NUMBER D2-14826

TITLE TECHNICAL FACILITY CRITERIA FOR THE MINUTEMAN LAUNCH
FACILITIES - FRANCIS E. WARREN AFB, WYOMING (U)

The technical facility criteria document for the Minuteman Launch Facilities at Francis E. Warren AFB is issued as a supplement to the Wing III Launch Facility criteria presented in Boeing Document D2-13797. The complete Wing V Launch Facility criteria consists of the following:

FWAFB LAUNCH FACILITY	02-14826	PAGE	13
INTEGRATED CRITERIA	FIG. 5-4		
GROUNDING LOCATIONS			
THE BOEING COMPANY			
DATE			
REVISED			
CALC			
CHECK			
APP			
APP

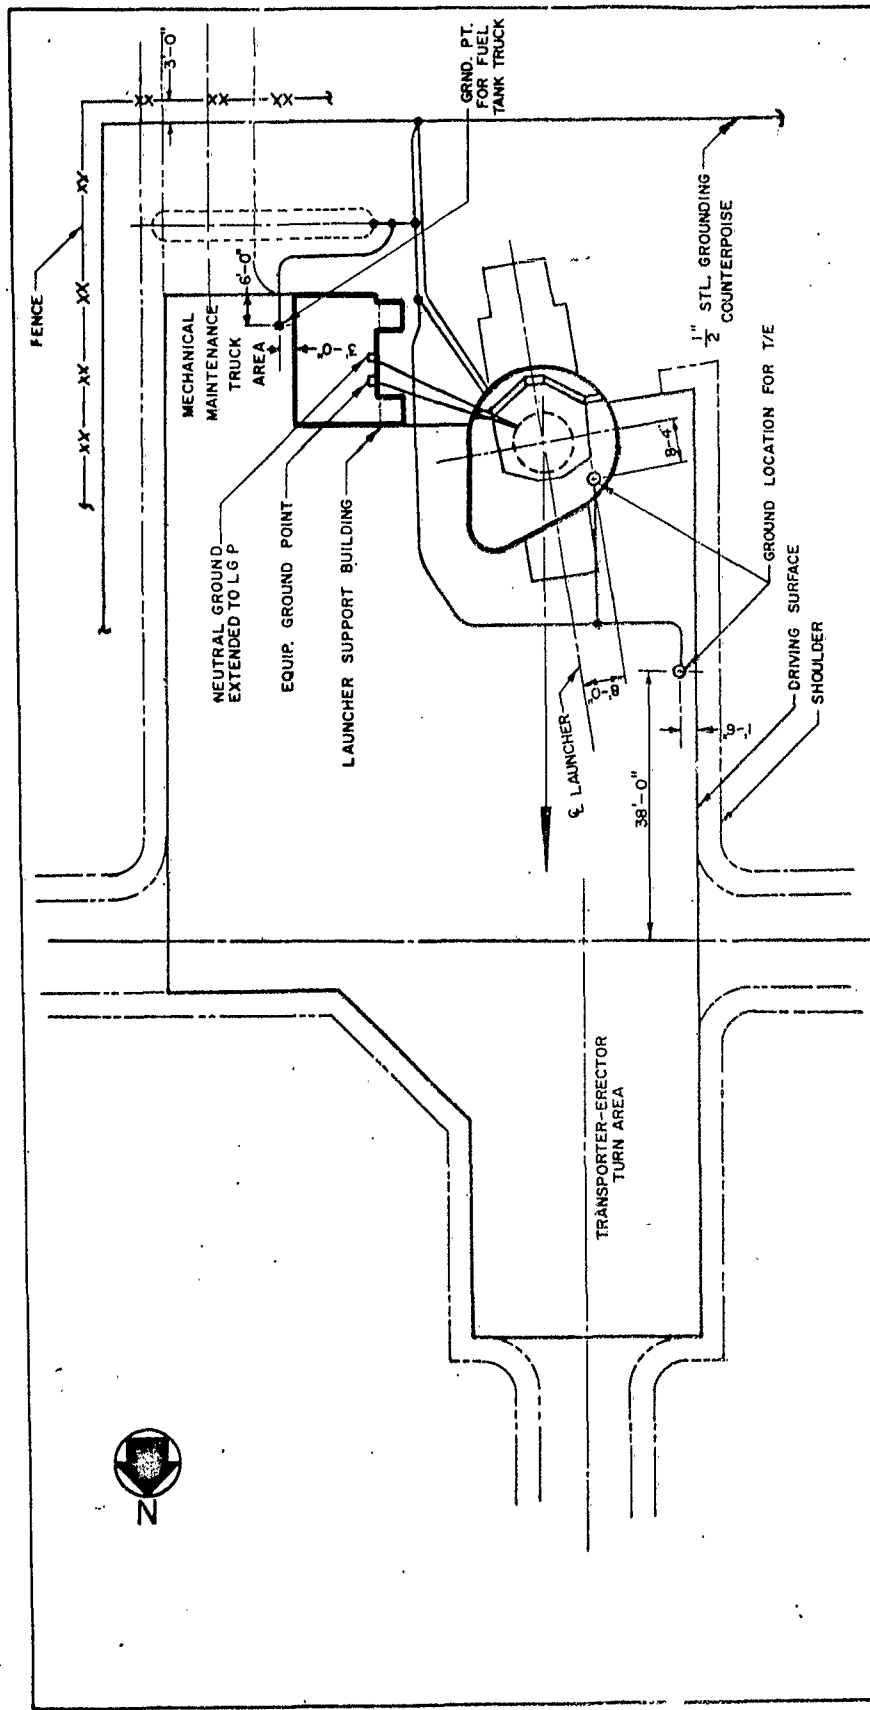
5.11.2 Figure 5-4 is revised to show peculiar conduit layout to grounding points for FWAFFB.

CALC	REVIS	DATE	FWAFB LAUNCH FACILITY SERVICE AREA & ACCESS ROADS CONDUIT ROUTING & PASSIVE REFLECTOR LOCATION THE BOEING COMPANY	D2-14826
CHECK				FIG. S-74
APP				PAGE
APP				15

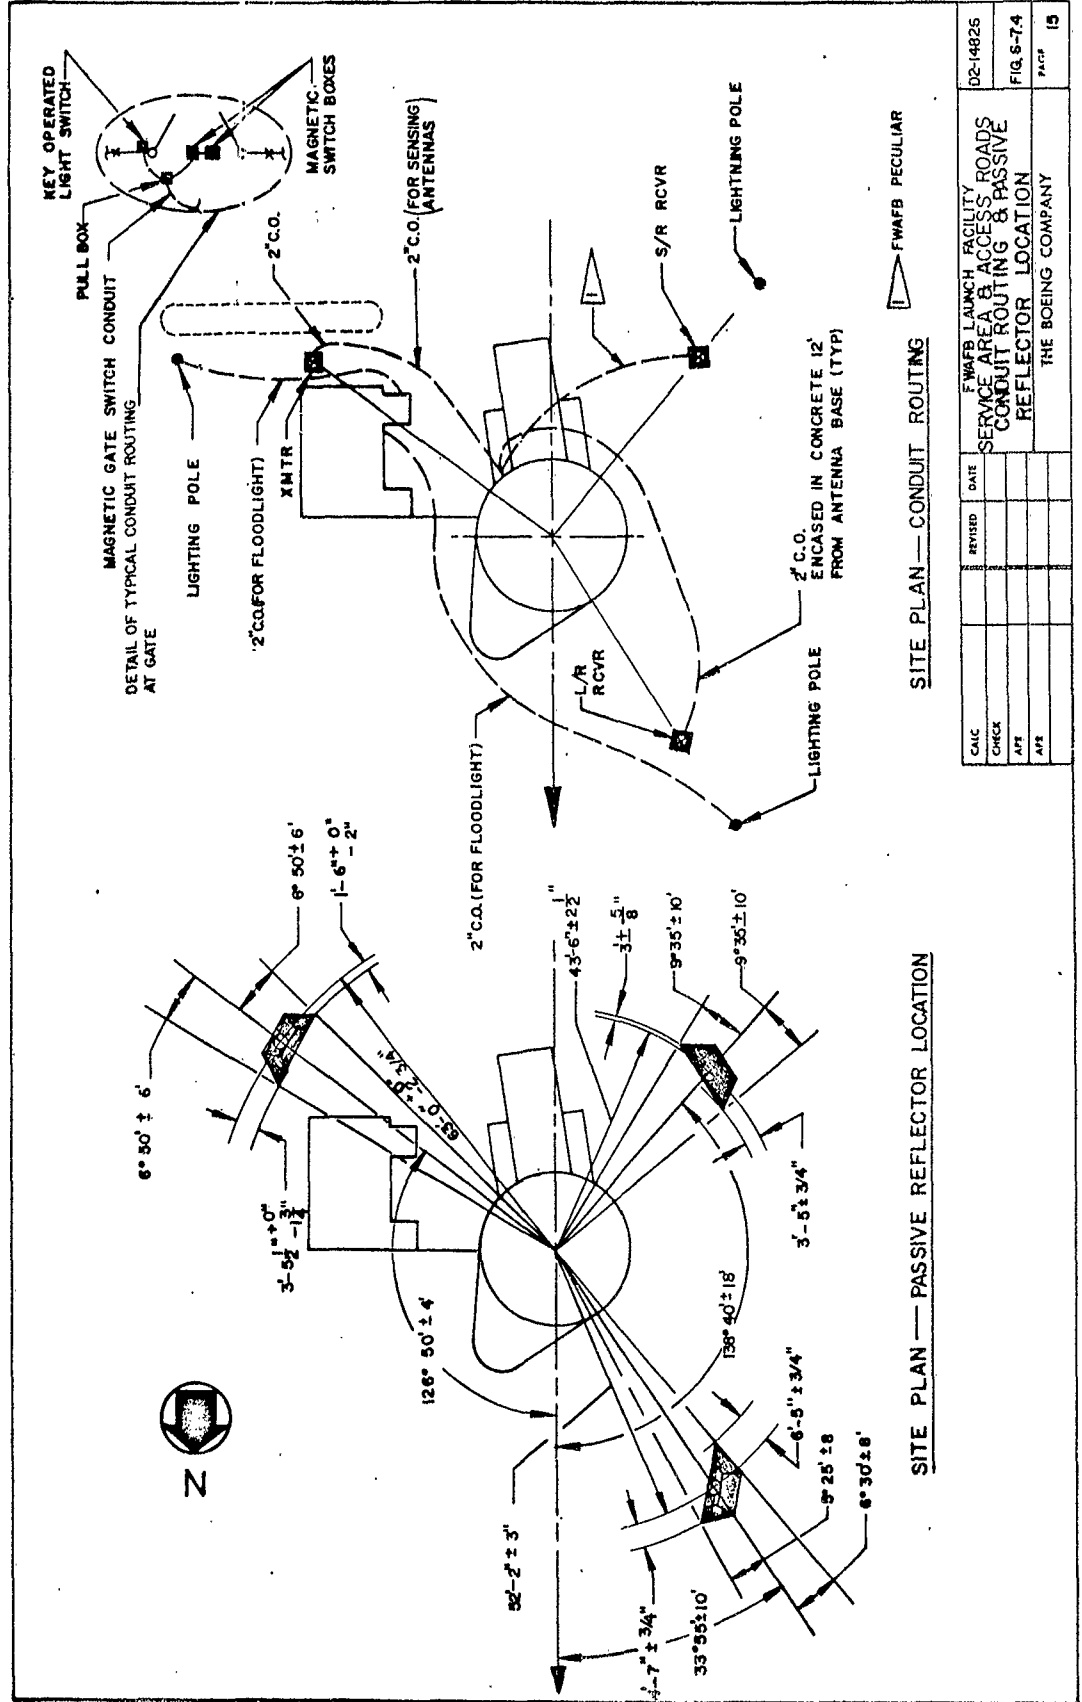
6.10.1 Figure 6-7.4 deletes Security J-Box located near XMTR antenna and also the 2" c.o. extending between the Security J-Box and the S/R RCVR. A conduit is added between the Launcher and the S/R RCVR.

DATE	REVISED	DATE	FWAFB LAUNCH FACILITY SERVICE AREA & ACCESS ROADS SECURITY POLE & J-BOX DETAILS	D2-14826
CALC				
CHECK				
APP				FIG. 6-76
APP			THE BOEING COMPANY	PAGE 16

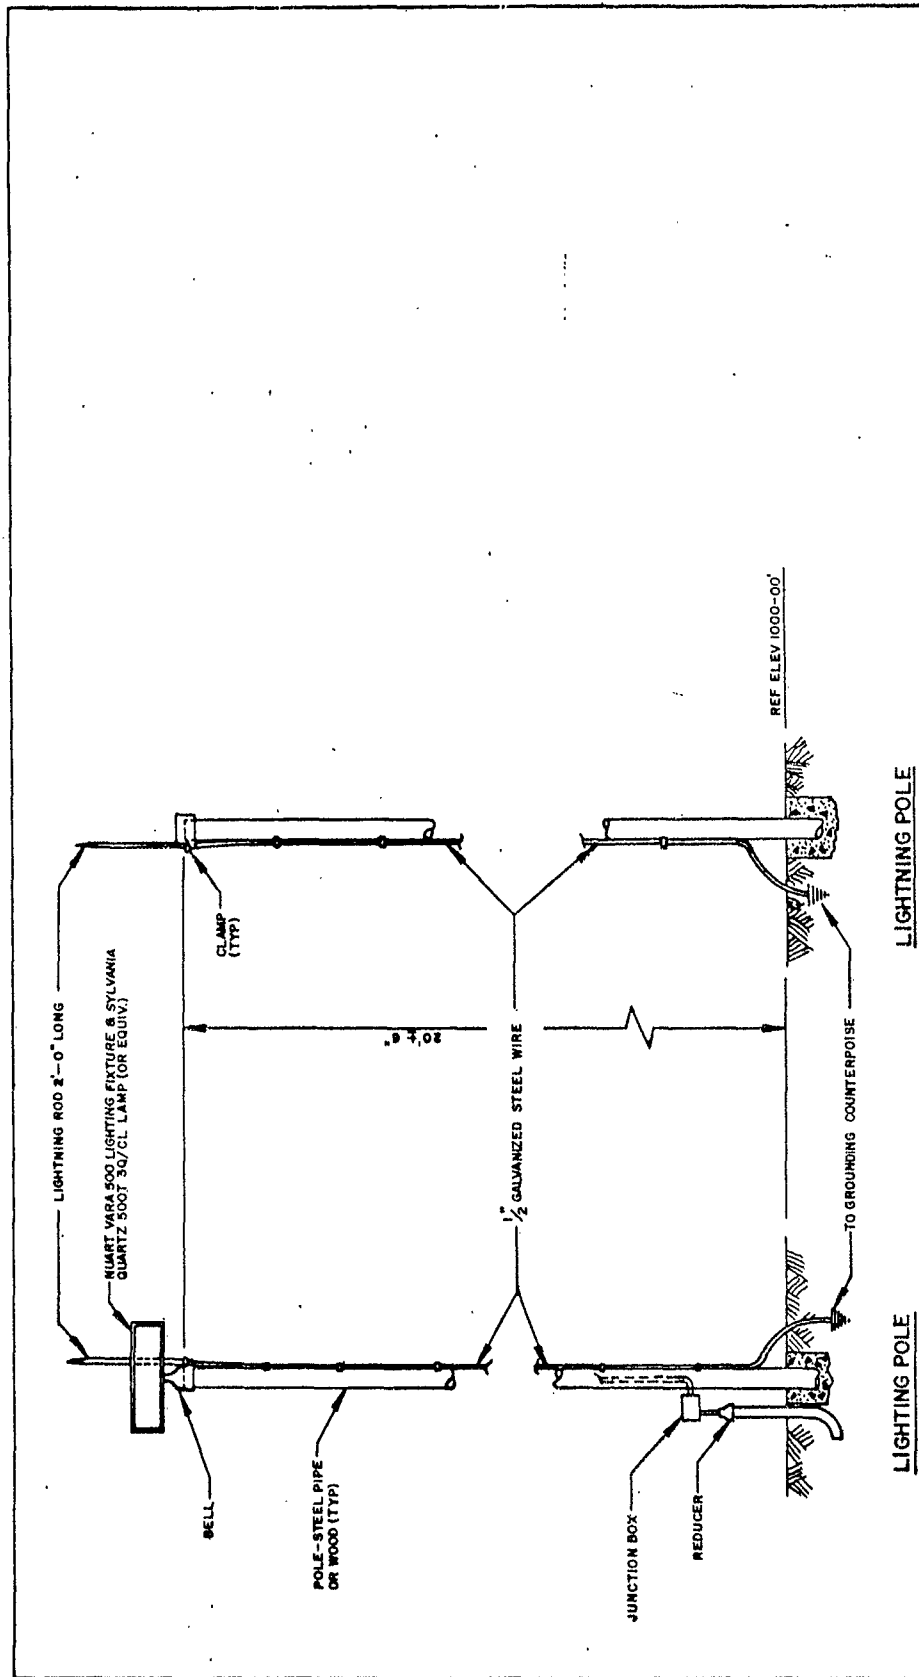
6.10.2 Figure 6-7.6 deletes Detail 1 and Section A of the Security J-Box.

CALC	REVISED	DATE	FWAFB LAUNCH FACILITY	D2-14826
CHECK			LAUNCHER SUPPORT BUILDING	FIG. 7-2.1
APP			ELECTRICAL CONDUIT DETAILS	PAGE 21
APP			THE BOEING COMPANY

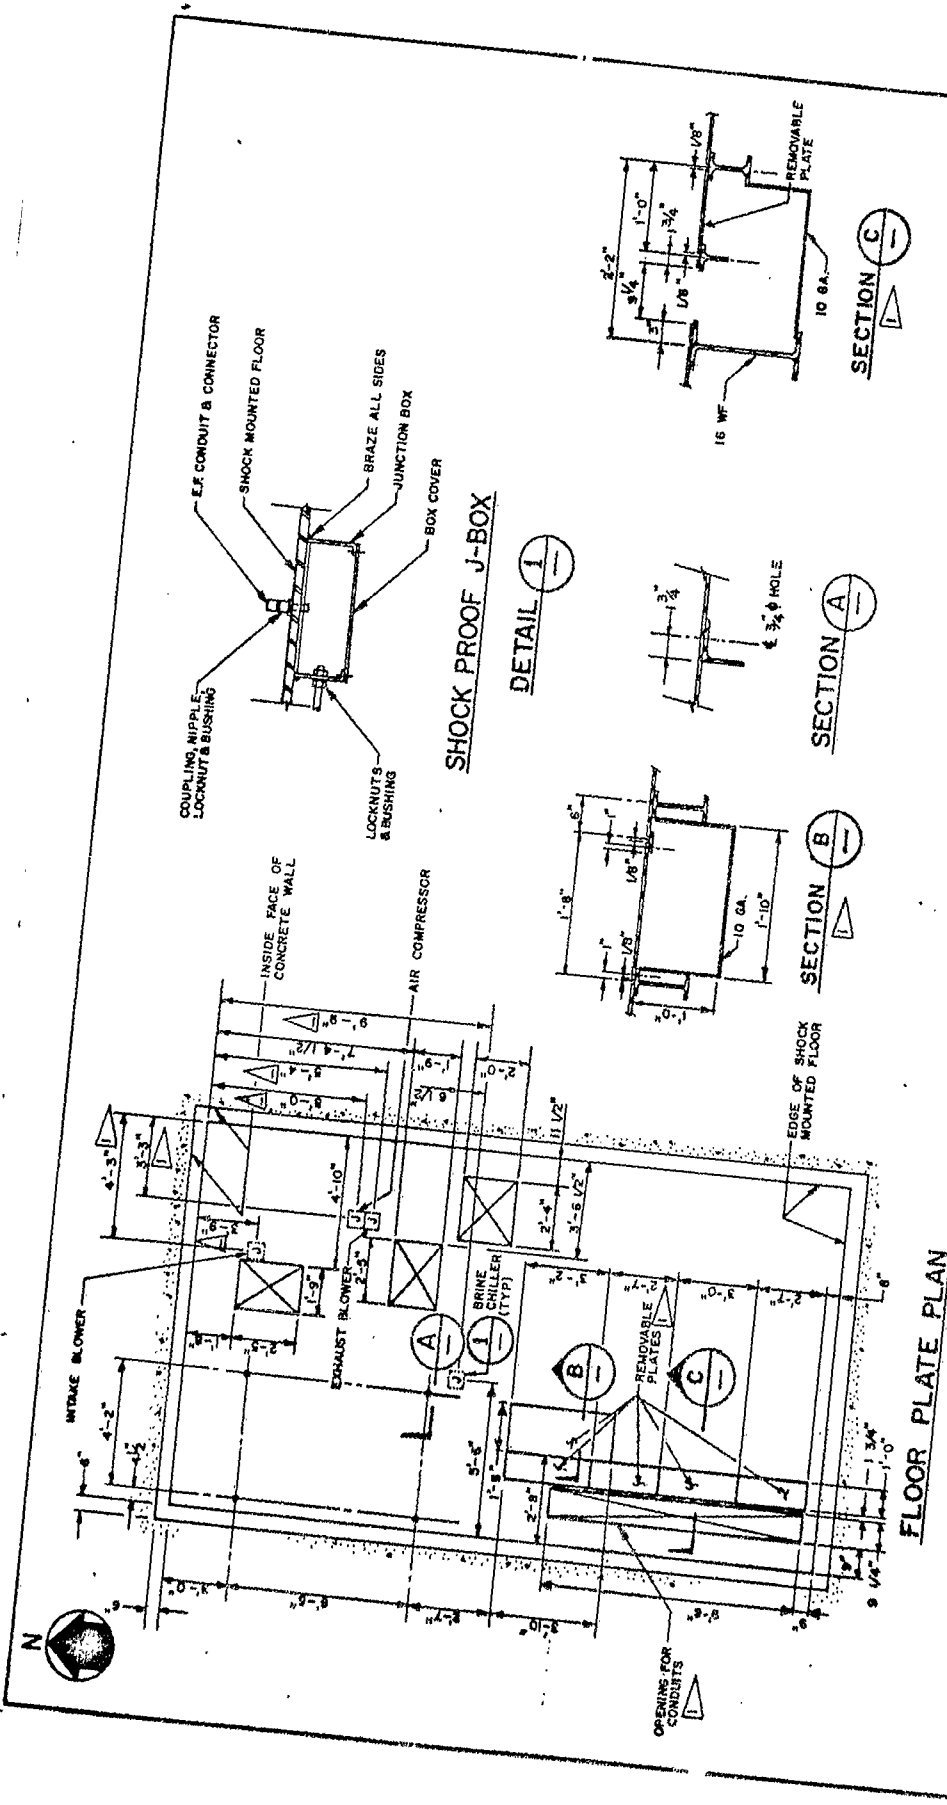
7.8.4 Figure 7-2.1 relocates the intrasite cable penetrations at the LSB exterior wall.

CALC		REVISED	DATE	F W A F B LAUNCH FACILITY	D2-14826
CHECK				LAUNCHER SUPPORT BUILDING	
APP				SWITCHBOARD ELEVATION	FIG. 7-2.3
APP				THE BOEING COMPANY	PAGE 23

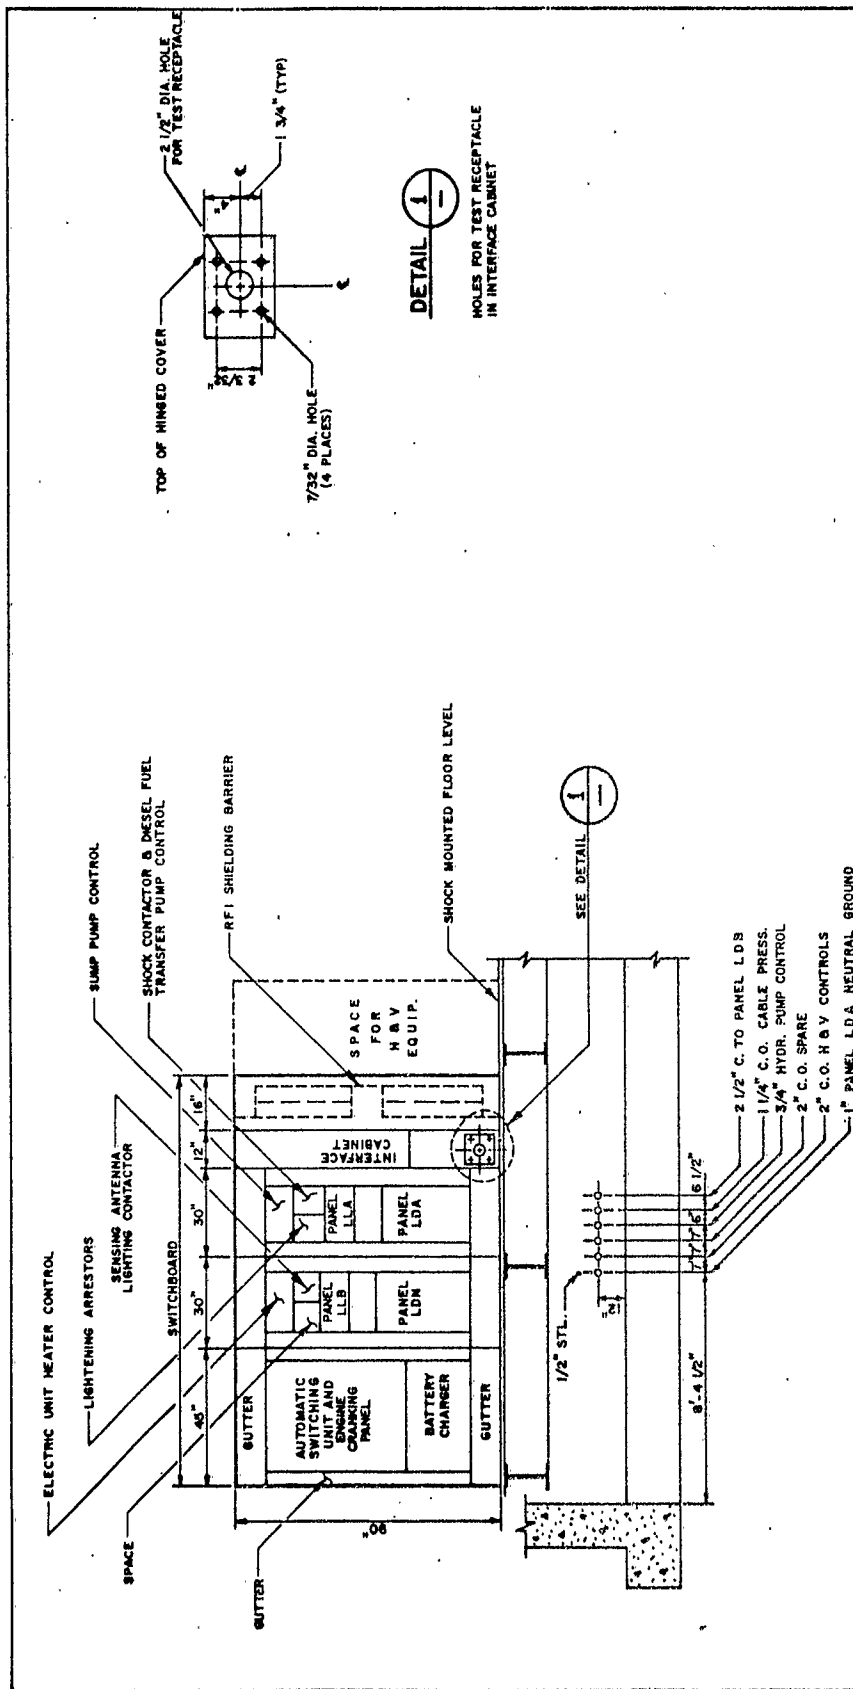
7.8.6 Figure 7-2.3 is added to show the switchboard panel elevation and necessary details.

CAIC	R.L. ORNESS	5/30/3	REVISED	DATE	FWAFB LAUNCH FACILITY LAUNCHER SUPPORT BUILDING INTERFACE CABINET CONNECTION DIAGRAM	D2-14826
CHECK						FIG. 7-3
APR						PAGE
APR						24
					THE BOEING COMPANY

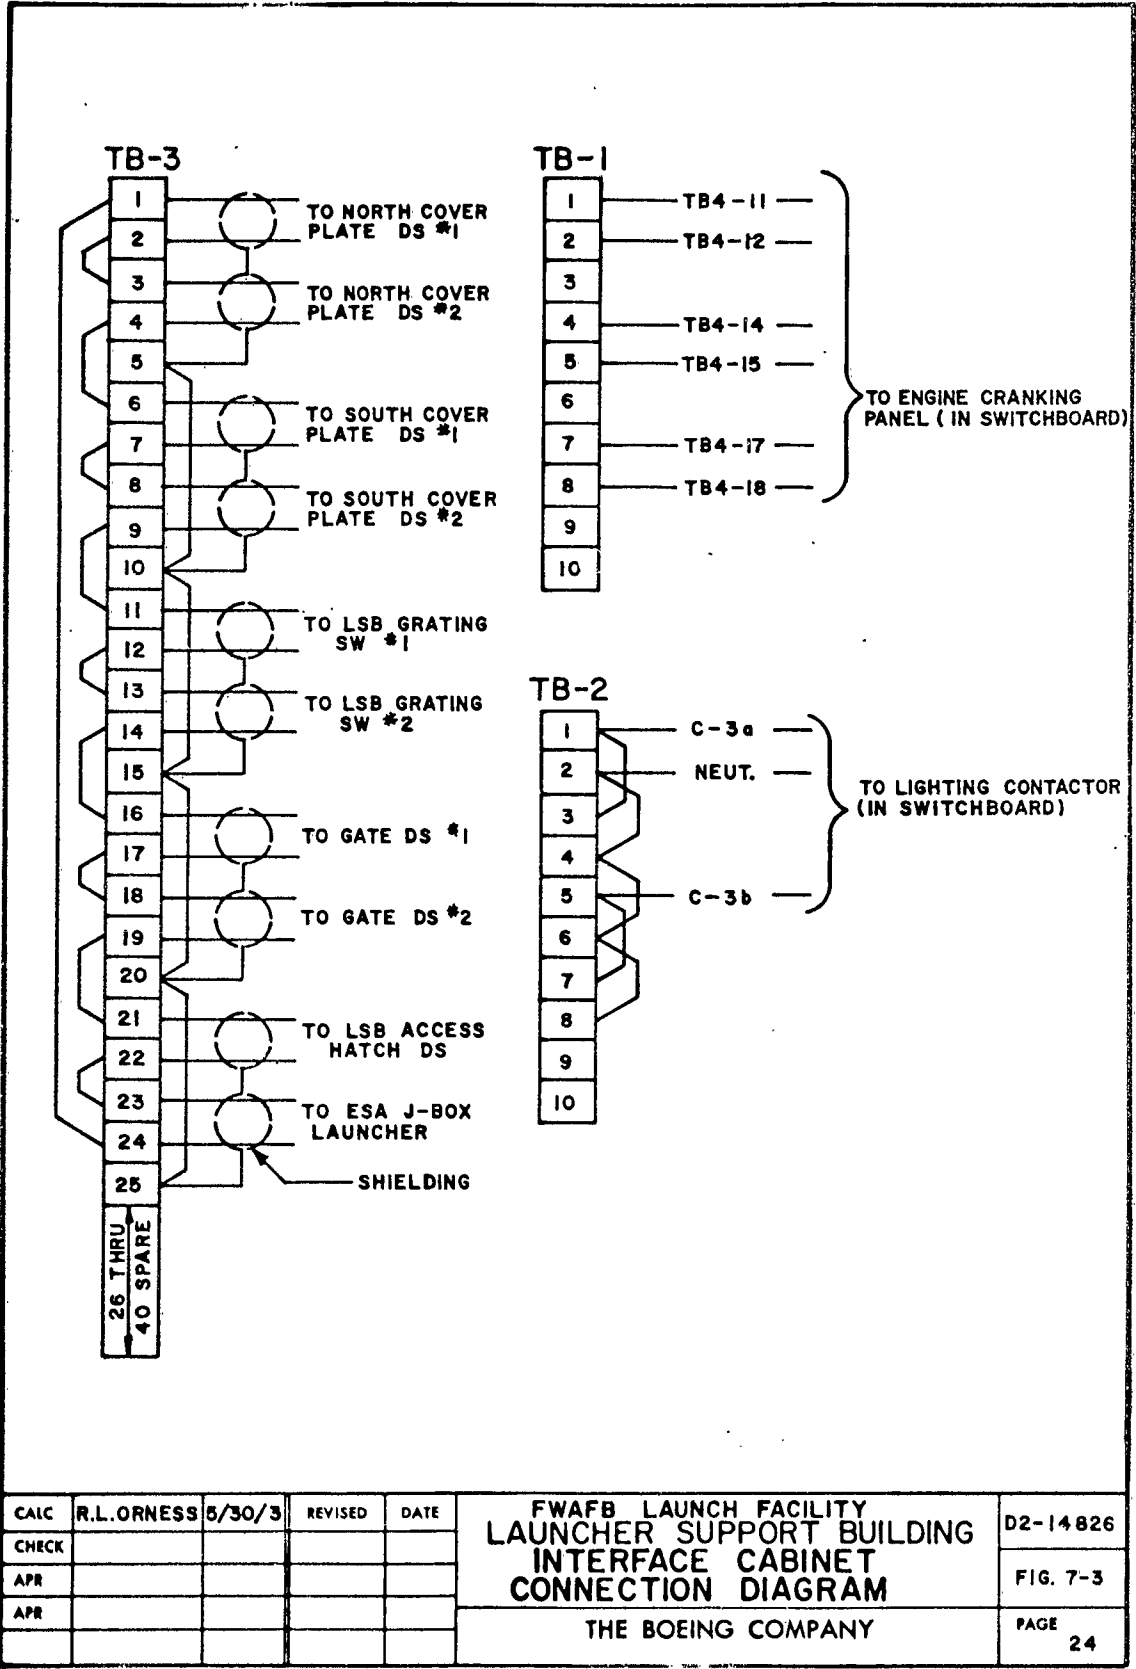
7.8.7 Figure 7-3 shows the wiring connection schematic for the Interface Cabinet. In lieu of a separate Security Terminal Cabinet as used in Wing III, the necessary security terminals shall be incorporated in the Interface Cabinet for Wing V.

FWAFB LAUNCH FACILITY	D2-14826
LAUNCHER EQUIPMENT ROOM	FIG. 9-1.7
PIPE SECTION & DETAILS	PAGE 28
THE BOEING COMPANY

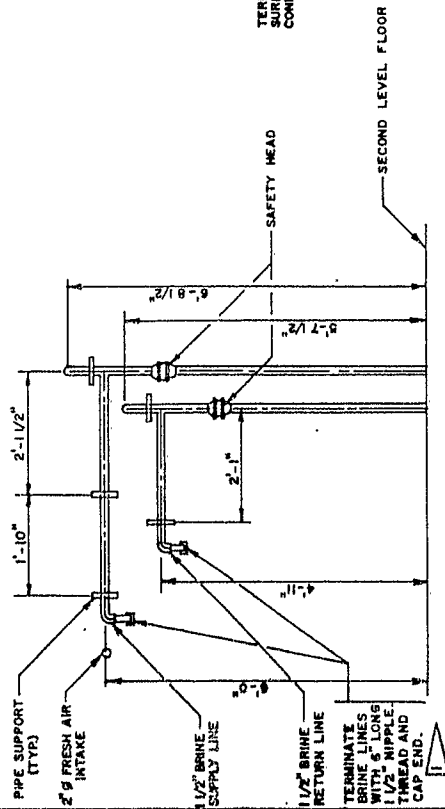
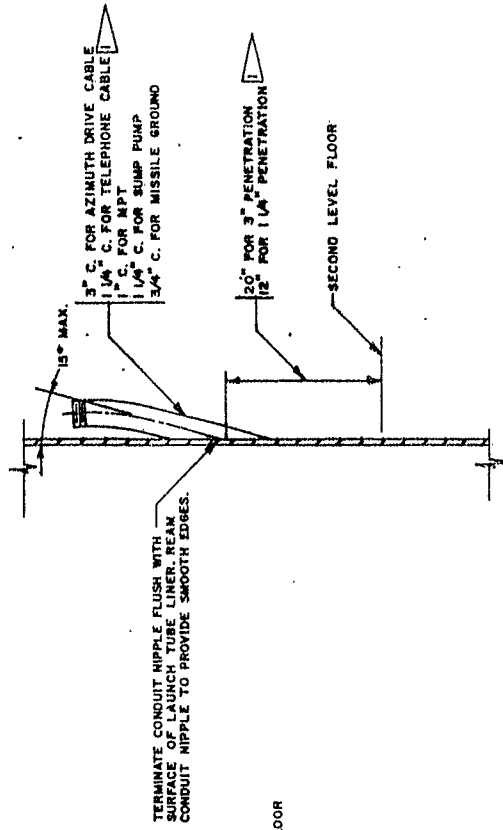
9.8.3 Figure 9-1.7 shows interface change at brine supply and return lines, Section A; and indicates a change in requirements for conduit penetration of line, Detail 2.
